Appendix L

# Response to Comments

In October, 2013, DNR released the Revised Draft Environmental Impact Statement (RDEIS) for the Olympic Experimental State Forest (OESF) forest land plan. Due to the interest shown by stakeholders and the public, DNR held an extended comment period (45 days instead of the required 30 days) for the RDEIS. During the extended comment period, DNR received comments from a wide range of individuals and organizations (Table L-1).

**Figure 15.** Western Strait of Juan de Fuca average annual coho spawning densities and cumulative percent exceedence for channel segments surveyed.

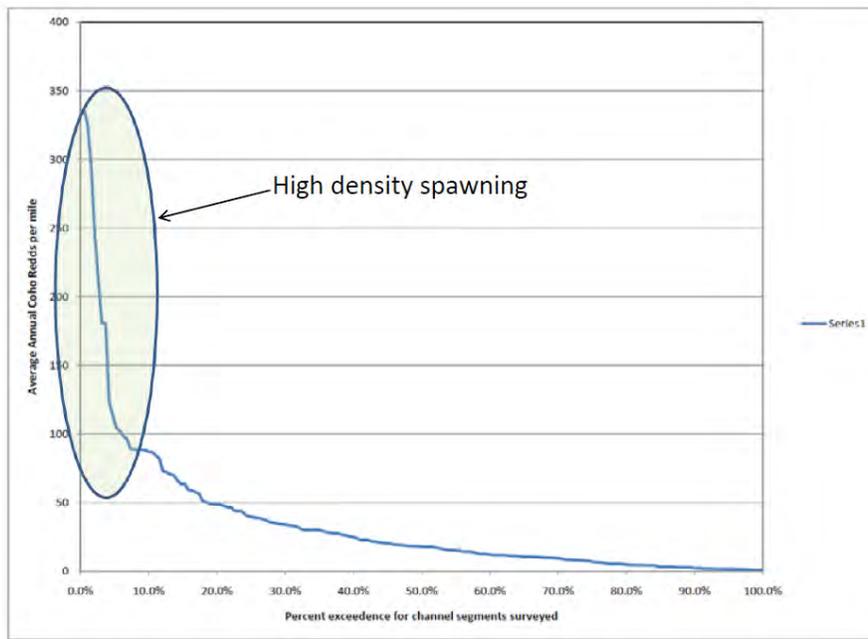
It is understandable that DNR does not have comprehensive data on fish distribution and habitat conditions throughout the OESF. The RDEIS uses one complex model, after complex model with little if any actual data to justify the adequacy of forest management activities. Forest management activities contained within the RDEIS should be based, at least in part, on fish distribution, status of stocks within a WAU, and habitat conditions. Furthermore, very highly productive stream reaches should not be treated with the same management prescriptions as less productive or non productive stream reaches. Not all habitats are equal. Risk from timber

harvest to riparian stands should not be equal across all habitats. None of these concepts were incorporated into the plan. It makes no sense to apply the same level of risk to all habitat types. Salmonid productivity throughout a WAU can be evaluated using multiple methods. For a species like coho salmon one surrogate for current productivity is spawning density (see **Figure 15**). For multispecies landscape scale approaches see Haggerty and NOLT (2011).

**Figure 17.** Two left bank tributaries to Clallam River Segment 12.

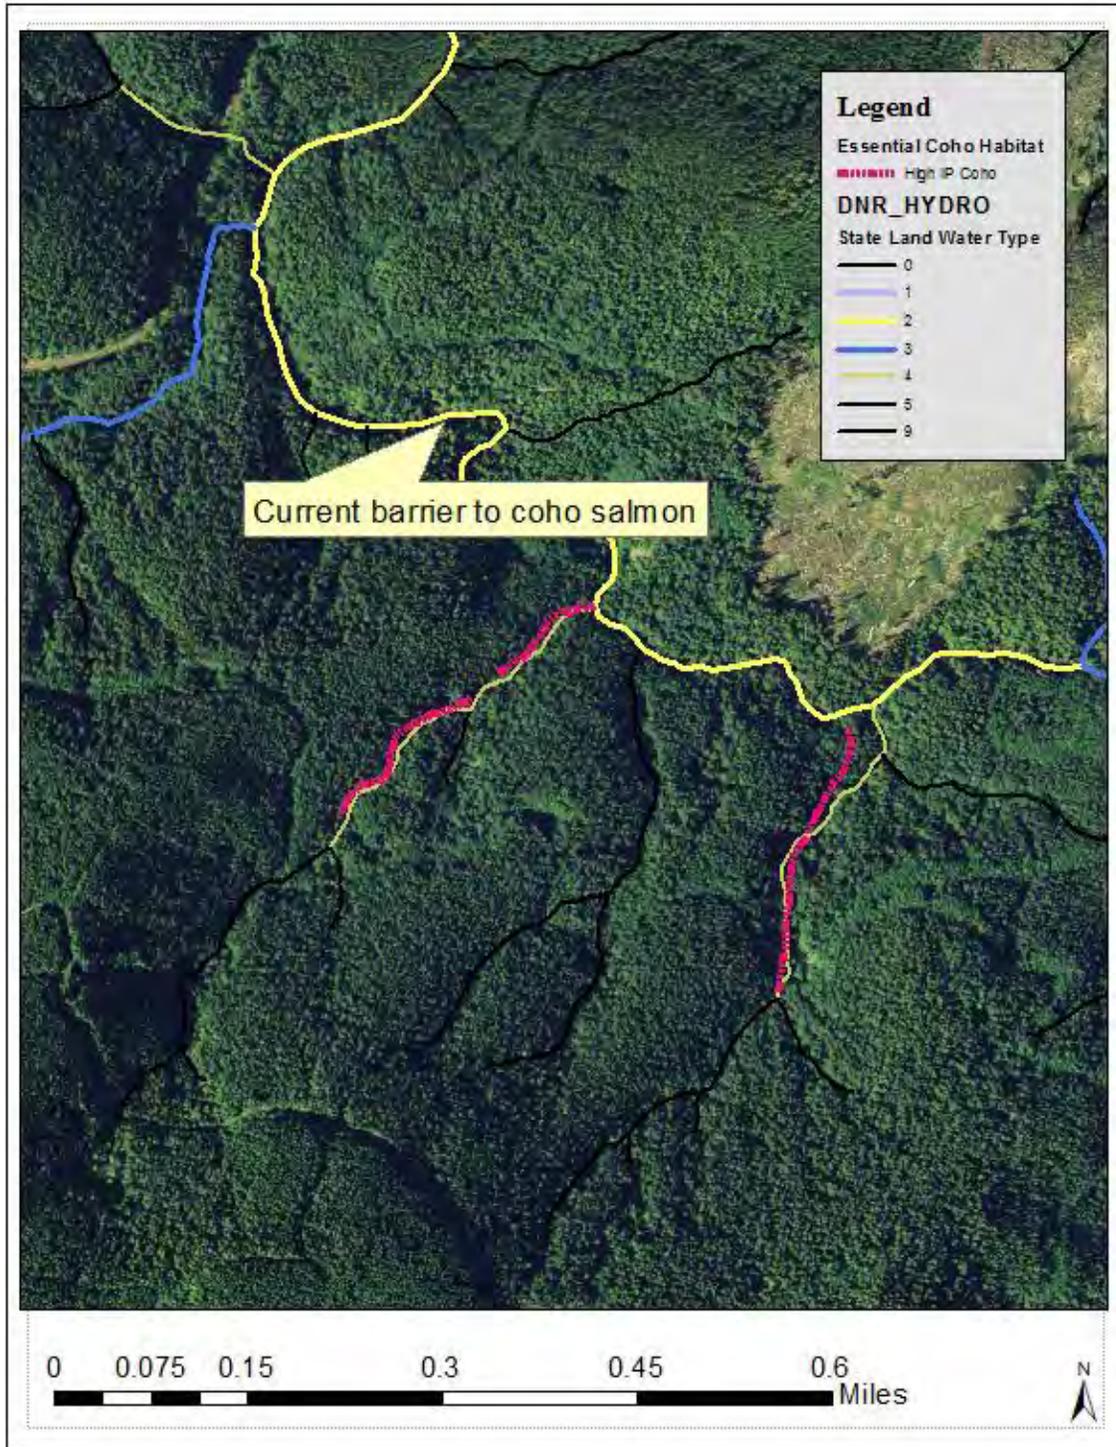
The next example includes two left bank tributaries to Clallam River Segment 14 (**Figure 17**). Both are upstream of a barrier (**Figure 18**) that currently limits upstream migration of coho salmon (based on a one day field survey that could only find steelhead and cutthroat trout upstream of the barrier). The stream to the west has a poor connection with the mainstem, and is unlikely accessible based my field survey. Stream gradient averages 19%. The stream is mapped as a Type 4 stream in the DNR hydro layer. Modeled as non-fish habitat in Forest Practice hydro layer, yet the stream is classified as "essential coho summer rearing habitat". The stream to the east also has a poor connection to the mainstem with a gradient averaging 18%. The stream is mapped as a Type 4 stream in the DNR hydro layer and modeled as non-fish habitat in Forest Practice hydro layer. But the stream is also modeled and mapped as "essential coho summer rearing habitat".

**Figure 19.** Map of Clallam River and tributaries near the Segment 11/12 break. Note large black dots are impassable waterfalls.

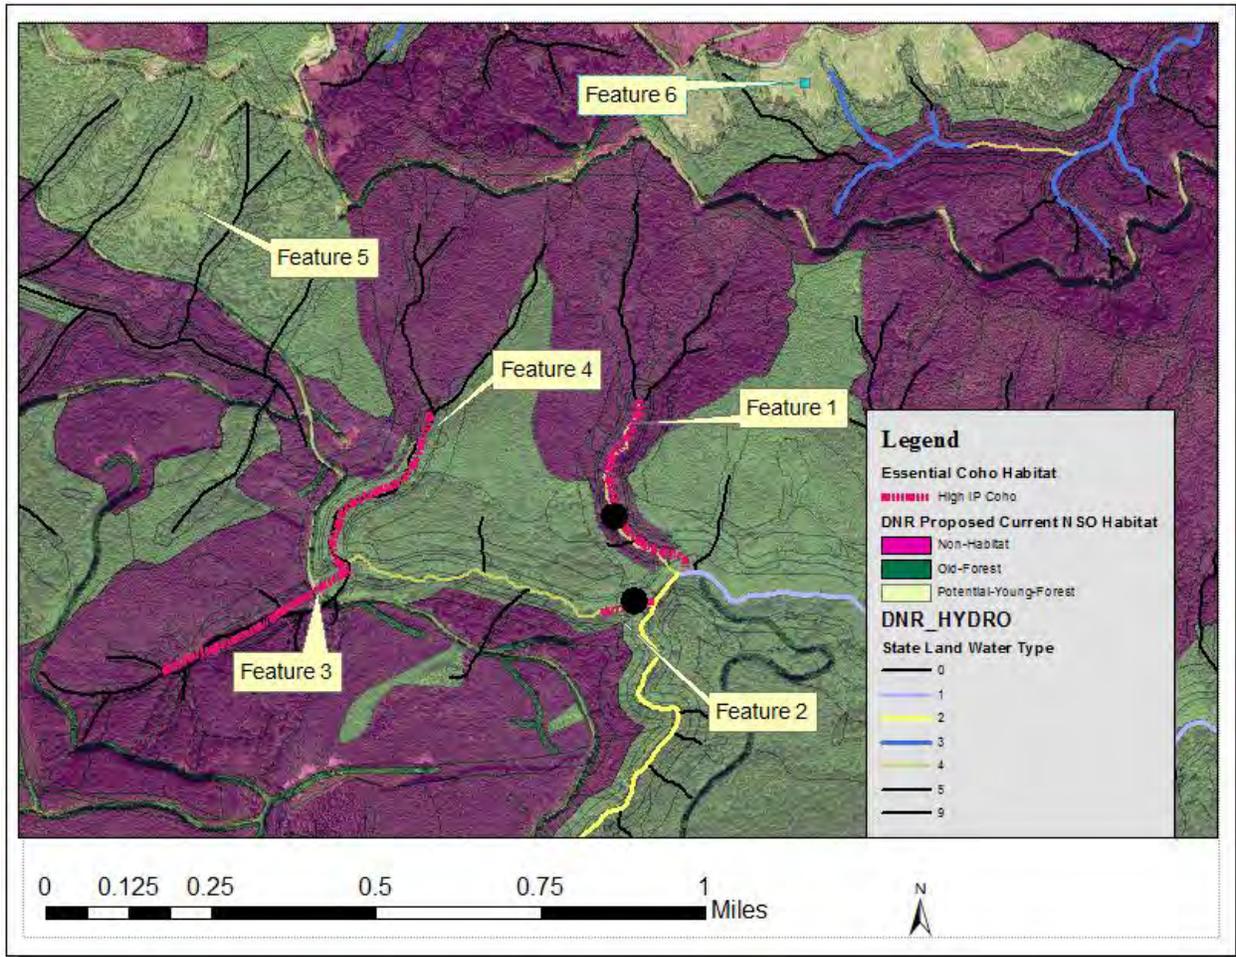
The next example is from an area around the Clallam River Segment 11/12 break (Haggerty and Clallam County 2008). This example includes numerous mapping and modeling errors. I will limit my comments to the six features and two waterfalls included in **Figure 19**. Feature 1 contains a few hundred feet of fairly steep (11%) habitat, then gradient picks up to 17%. There is an anadromous barrier within the "essential fish habitat" channel network. This stream is mapped as a Type 4 stream in the DNR hydro layer but modeled as fish habitat in Forest Practice hydro layer. Feature 2 was field surveyed and contains approximately 150 feet of good summer coho rearing habitat that is downstream of a waterfall approximately 30 feet tall. Features 3 and 4 are mapped as essential fish habitat but are upstream of the fish barrier described for Feature 2. Features 5 and 6 are included in this discussion based on their proximity to the other features described. Feature 5 is mapped as potential young forest. However, it was clearcut in 2012 and is not longer NSO habitat (Ridges Cleanup). Feature 6 is mapped as potential young forest but was clearcut in 2008 (P-1600 Blew Again). Features 5 and 6 provide additional examples of the differences between the modeled world and the real world.

I could provide endless examples of problems with mapped "essential habitat" for coho salmon summer rearing. However, it might be easier to show the erroneous nature of the "essential fish habitat" modeling by comparing the modeled output to DNR's water type layer (which is also full of errors). Within the OESF only 21% of the "essential habitat" for coho is classified as Type 1, 2, or 3 waters and 79% is classified as Type 4, 5, or unknown. Type 5 waters had the greatest length of channel classified as "essential fish habitat".

**Figure 20.** Map depicting Stumpy's Ride Unit 1 and a stand of potential old forest (mapped blue with stand birth label 1900).

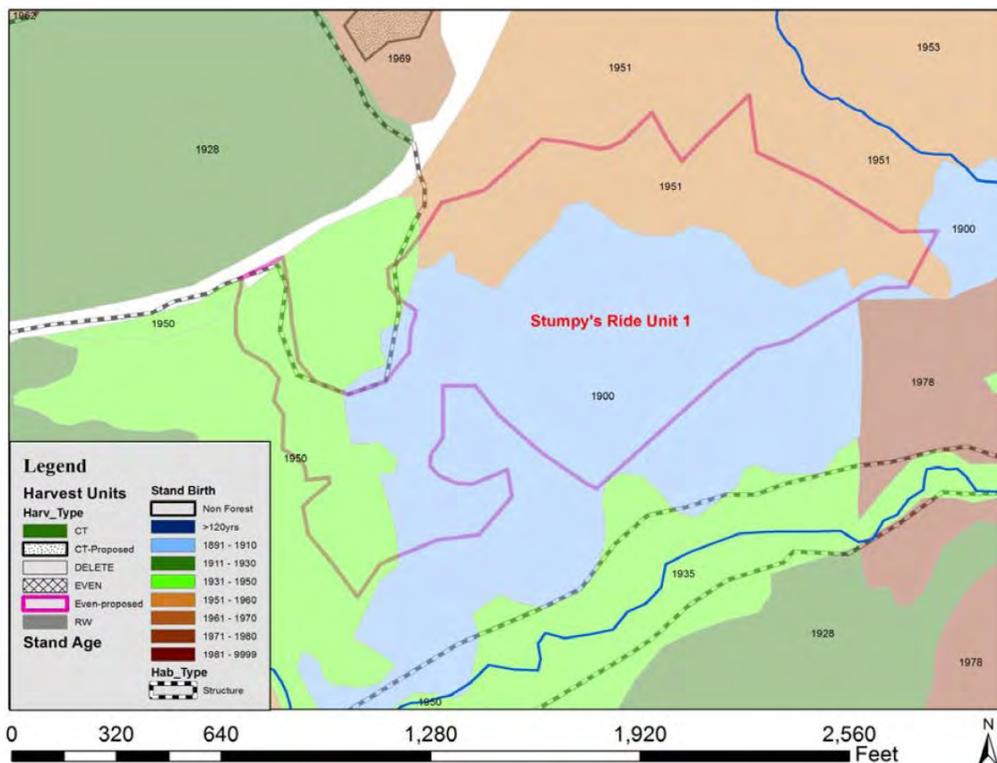
The Landscape Alternative proposes a new system to map and model NSO habitat in the OESF. Within the Clallam Landscape the proposed approach yields a significantly different old forest map (314 acres) compared to the current approach (0 acres). I reviewed several of the Old Forest polygons included in the proposed approach. One stand now classified as Old Forest caught my attention since I provided comments on this stand to DNR Division staff early this year. **Figure 20** includes a map of the stand (color light blue with stand birth 1900) and Stumpy's Ride Unit 1 (hollow polygon with pink borders).

During the Final SEPA Determination (Feb 11, 2013; SEPA File No. 12-11202) DNR concluded that the stand was not structural habitat. Now DNR is mapping the stand as Old Forest. It is difficult to reconcile how two vastly different determinations can be made in a single year. It

**Figure 21.** RDEIS map of NSO Habitat Landscape Alternative at decade 6 contrasted with even-age harvest units (from 1997-2013) within a portion of the Clallam LPU (source: harvest unit boundaries come from unpublished mapping work I conducted for OFCO).

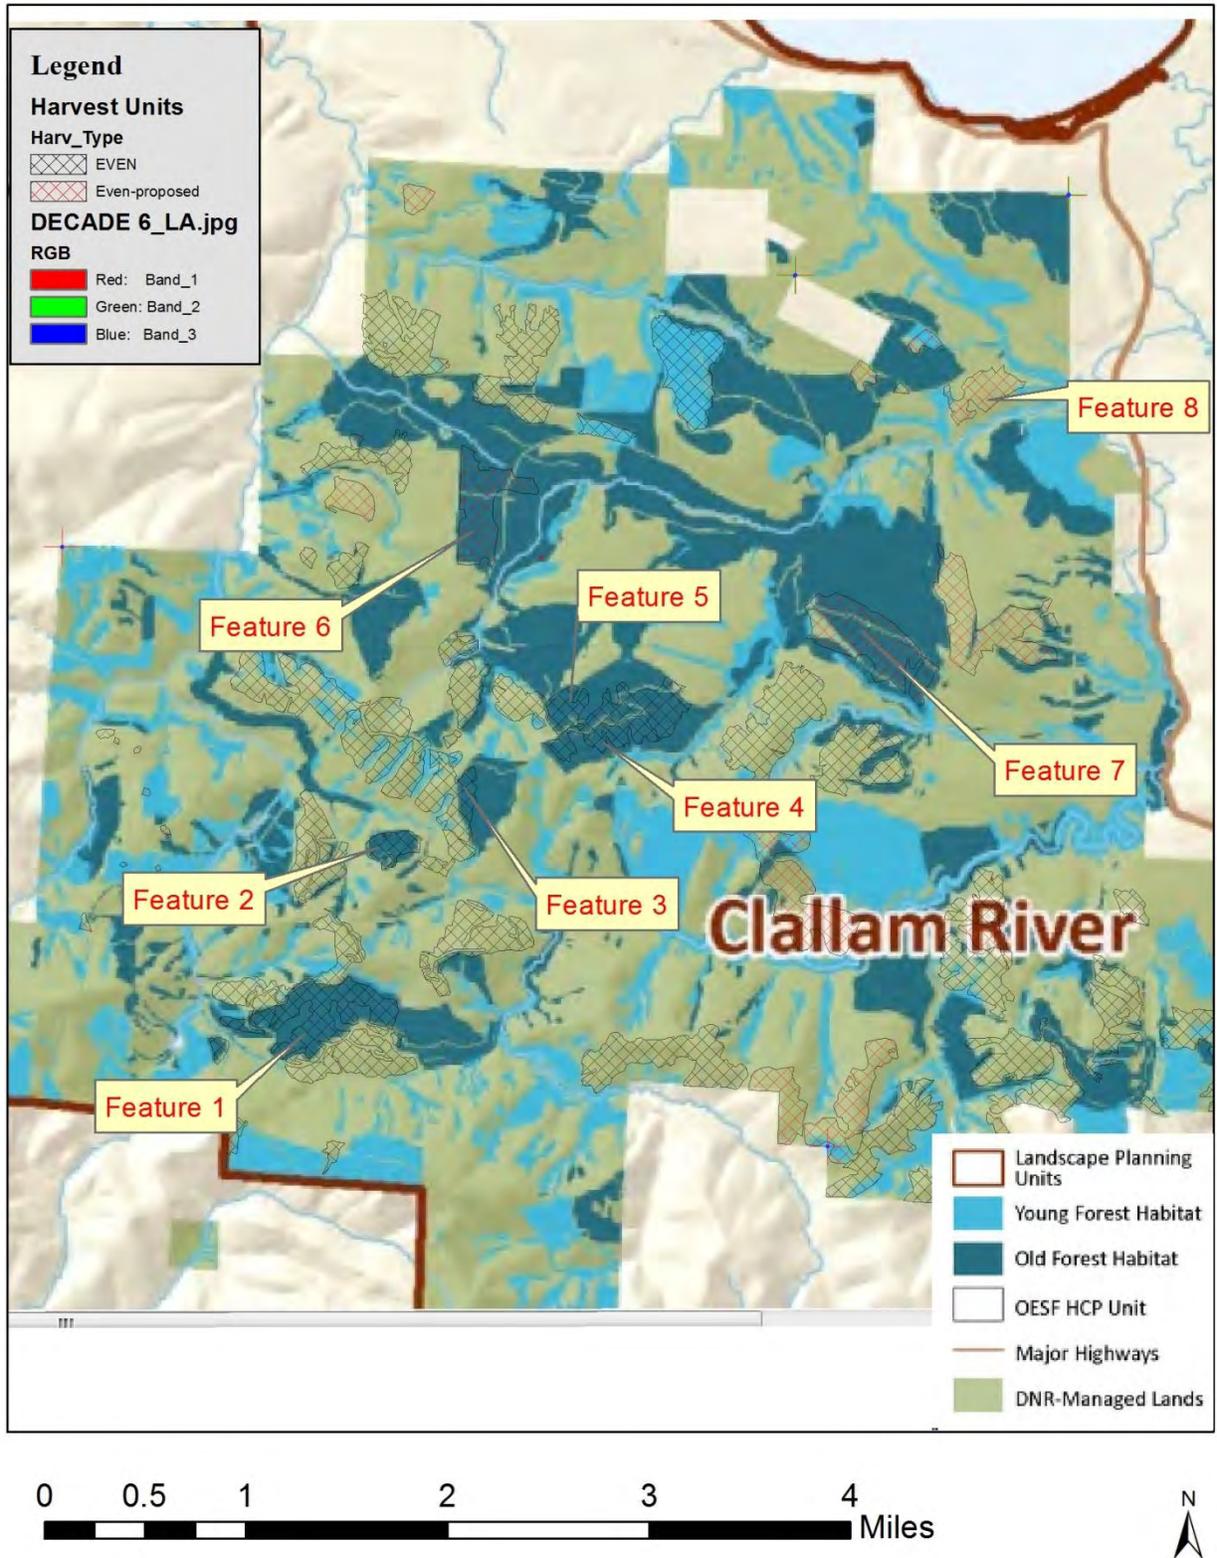
appears that DNR on-the-ground management is based on modeled outputs versus on-the-ground conditions. This requires a tremendous amount of faith in "The Model" that often does not reflect current, on-the-ground conditions. For example, **Figure 21** below depicts several stands projected to be "Old Forest" in decade 6 of the Landscape Alternative that have been recently clearcut. I will describe each of the labeled features in the **Figure 21**.

Feature 8. This is Stumpy's Ride Unit 1 to be clearcut in 2014. Proposed mapping classified as "Old Forest", stand age is 107 in the DNR stand inventory data used by the Estate Model. Projected to be non-habitat in Decade 1 and 6.

Based on reviewing this portion of the Clallam Landscape I estimate that roughly 9% of the projected "Old Forest" in Decade 6 will be between 60 and 70 years old (estimate includes stands which have experienced greater than 50% canopy loss from windthrow). There is a serious problem with the modeling of future "Old Forest" conditions based on current stand conditions. I do not have all of the information needed to determine the factors that are producing the erroneous "Old Forest" classifications predicted at decade 6. The modeling work needs to be redone in order accurately predict future "Old Forest" conditions.
